Westmead Hospital Central Acute Services Building

*State Significant
Development
Modification Assessment
(SSD 7642 MOD 3)*

August 2019

Figure 2 | Proposed signage locations

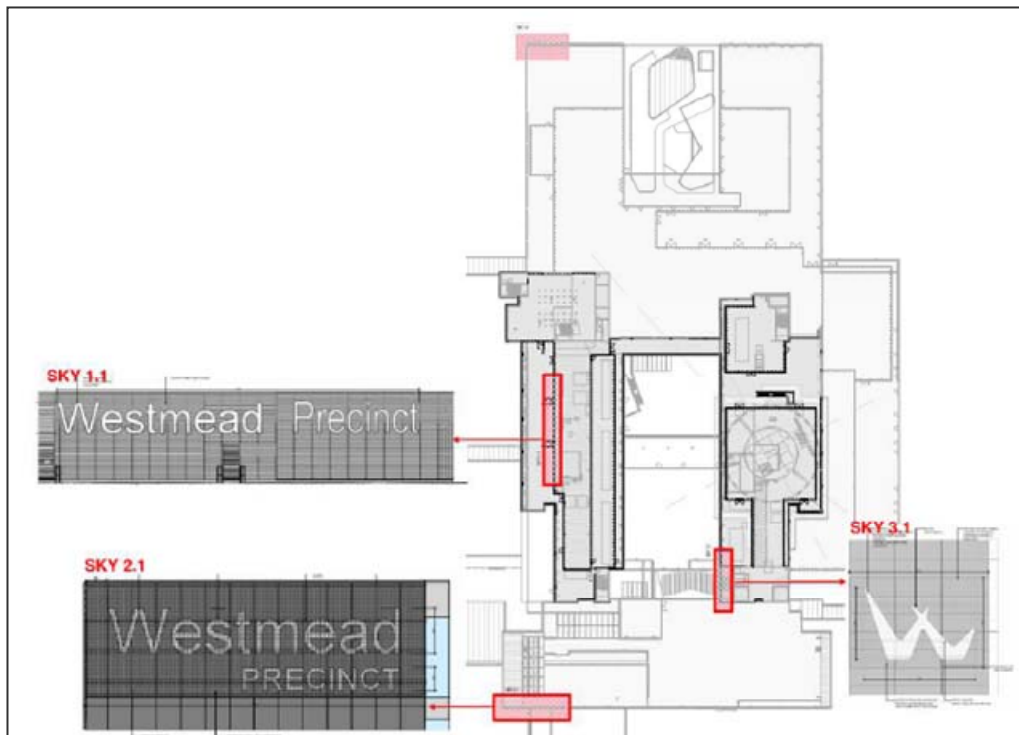
The Department is satisfied that the proposed signage is compatible with the Westmead Precinct and the CASB in content and form. The signage's institutional branding would reinforce the precinct's coherence and identity across its different functions and built forms. While the Department recognises that the proposed signage is large in scale (varying between 30sqm and 100sqm), this size must be considered in the context of the scale of its host building and its built form environment. The proposed signage has been designed such that its size and location responds appropriately to the scale and articulation of the building's facades. The Department considers the signage is appropriate for the building and its urban design setting.

Figure 6 | Separation between residential properties and nearest sign (green arrow)

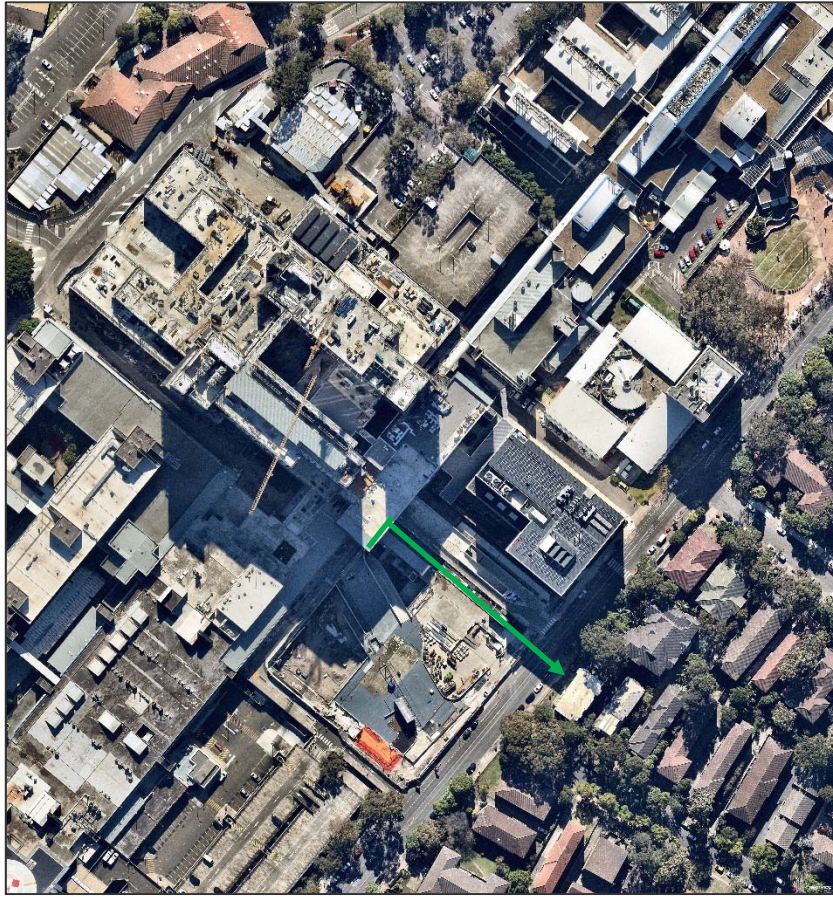
The proposed signage would be illuminated and has the potential to cause amenity and road safety impacts. The closest sign is located approximately 100 metres from the nearest residential receiver and 80 metres from the nearest public road (Hawkesbury Road), as shown in **Figure 6**.

The signage would be illuminated by lightboxes within each of the letters. The Applicant provided a technical assessment of the proposed illuminated signage that assessed the potential amenity impact of the illumination. It acknowledged that the signage, particularly sign SKY 2.1, would be visible from residential properties on Hawkesbury Road. The assessment found that the proposed lighting is similar in nature and intensity to other lighting around the hospital and recommended a maximum luminance 250cd/sqm and installation of a dimmer to allow the illumination to be adjusted if necessary.

The Department notes that this is the maximum luminance recommended for suburban areas by Australian Standard AS4282-2019 – Control of the obtrusive effects of outdoor lighting, which is the current and applicable Australian Standard. The Department concurs with the recommended maximum luminance and recommends that it is subject to a condition of consent. The Department is satisfied that the combination of the proposed signage's separation from residential receivers and the proposed limit to its luminance will avoid unacceptable amenity impacts on neighbouring residents.
